DART AEROSPACE LTD	Work Order: 79883
Description: Crosstube Assembly, Mid Fwd	Part Number: D206-667-147TRN
Inspection Dwg: D206-667-147 Rev: A	Page 1 of 1

DART AEROSPACE LTD HAWKESBURY, ONTARIO, CANADA	
DRAWING NO. D206-667-147	REV. A SHEET 1 OF 4
TITLE CROSSTUBE ASS'Y (206L MID FWD)	SCALE NTS

DRAWING NO. D206-667-147	TITLE CROSSTUBE ASS'Y (206L MID FWD)	REV. A	DART AEROSPACE LTD ENGINEERING ORDER		D.E.O. NO. D206-667-147-A-1	SHEET NO. SHEET 1 OF 1	SCALE NTS
DRAWN <i>q</i>	CHECKED <i>AS</i>	MFG. APPR. <i>AS</i>	APPROVED <i>MD</i>	DE APPR. <i>MD</i>			
DATE 11.07.15	DATE 11.07.20	DATE 11.07.21	DATE 11/07/21	DATE 11.07.21

REPLACE MAGNOBOND WITH PROSEAL.

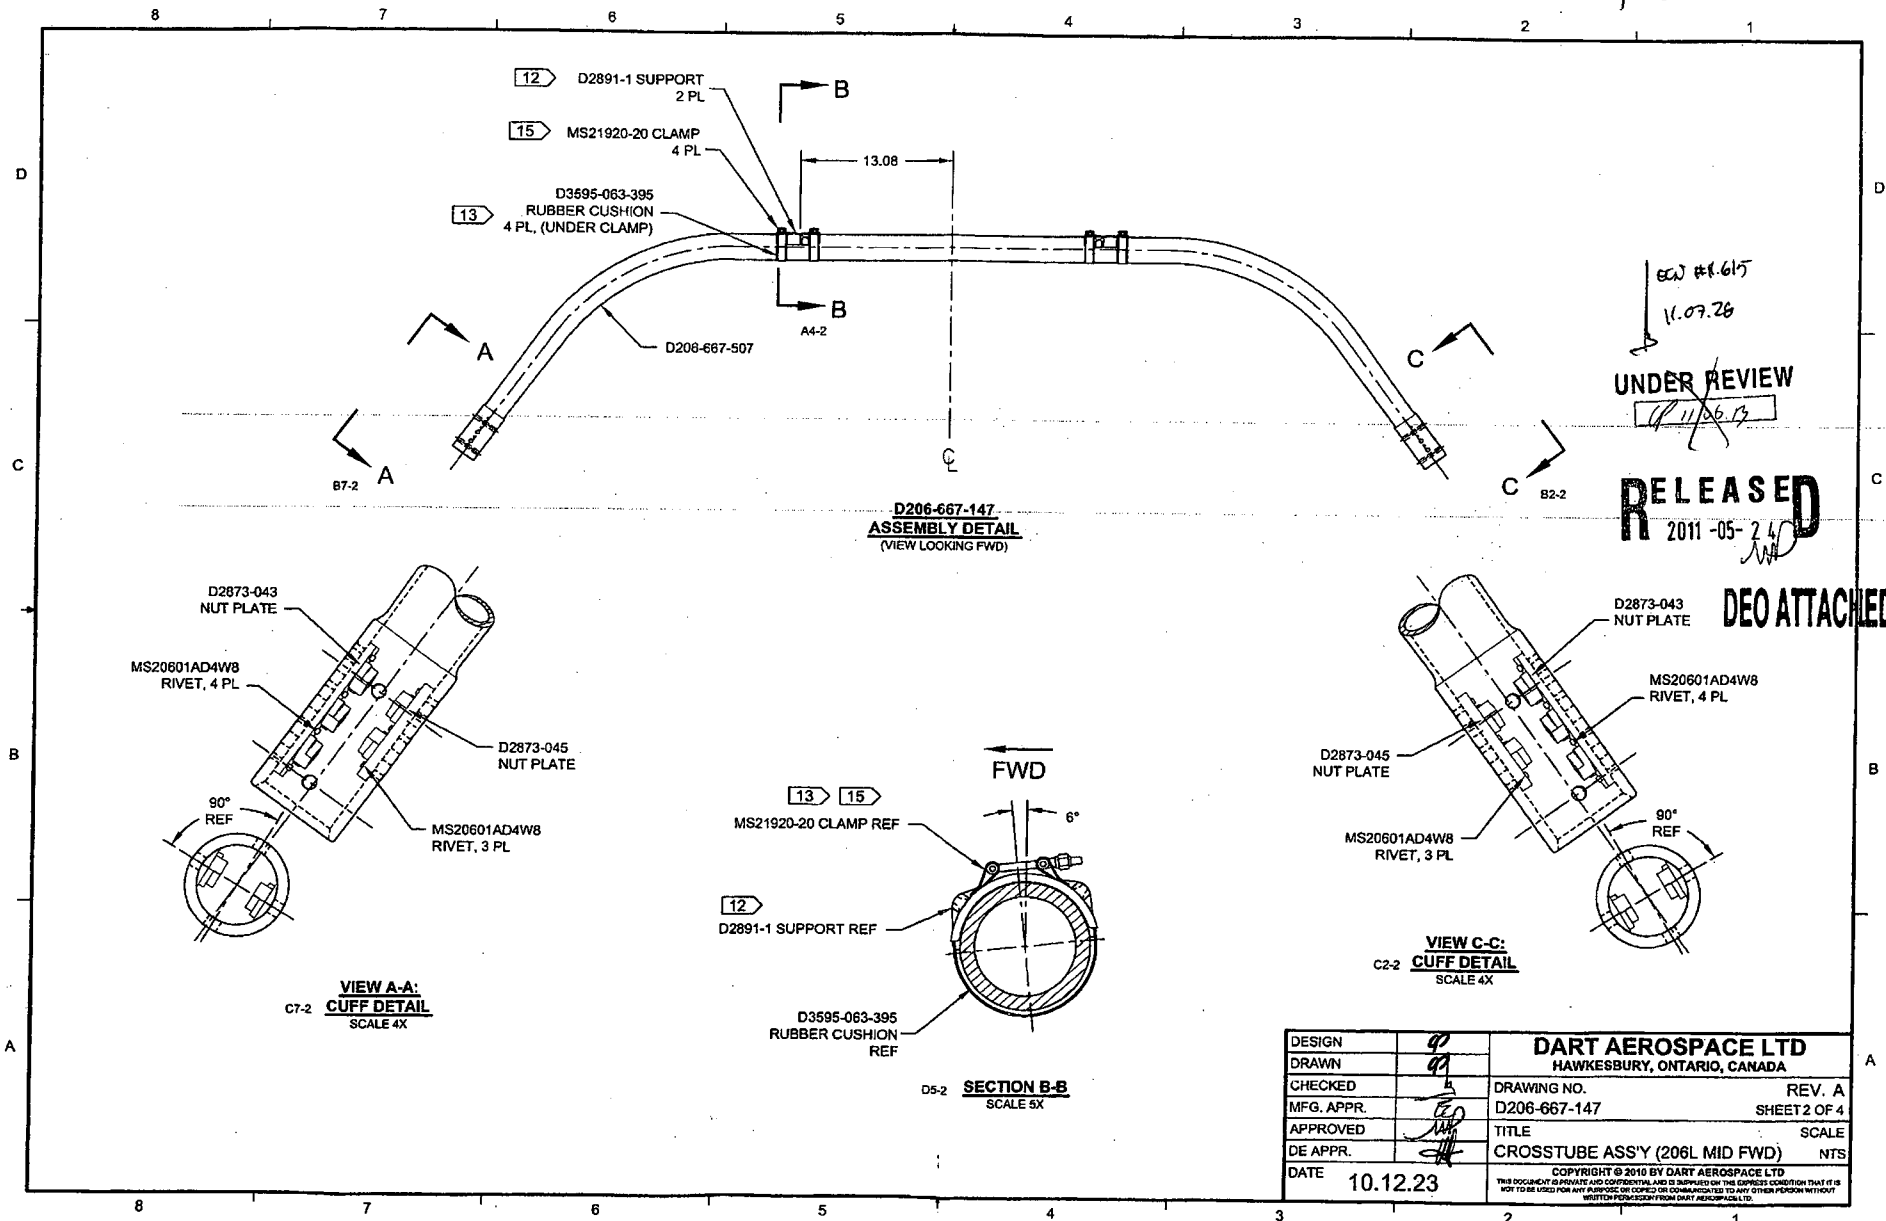
NOTE 12 & 15, SHEET 1 IS AMENDED AS FOLLOWS:

Item	Qty -147	Part Number	Description
9	A/R	PROSEAL 890 B-2	SEALANT, AMS-S-8802 CLASS B-2

- 12) TO INSTALL D2891-1 SUPPORT: ABRASE MATING SURFACE OF SUPPORT AND CROSSTUBE WITH 180-GRIT SANDPAPER AND REMOVE RESIDUE WITH MEK (OR EQUIVALENT). APPLY A 0.04" TO 0.07" THICK LAYER OF PROSEAL 890 CLASS B-2 (OR AMS-S-8802 CLASS B-2) SEALANT TO MATING SURFACE OF SUPPORT.
- 15) TORQUE CLAMPS 80 TO 100 IN-LB. ENSURE AT LEAST 1.5 THREADS SHOWING IN SAFETY AND THAT NUT HAS NOT BOTTOMED-OUT AFTER TORQUING. **PRIOR TO PACKAGING, RE-CHECK TORQUE ON CLAMPS AFTER PROSEAL 890 SEALANT HAS CURED FOR 72 HOURS.**
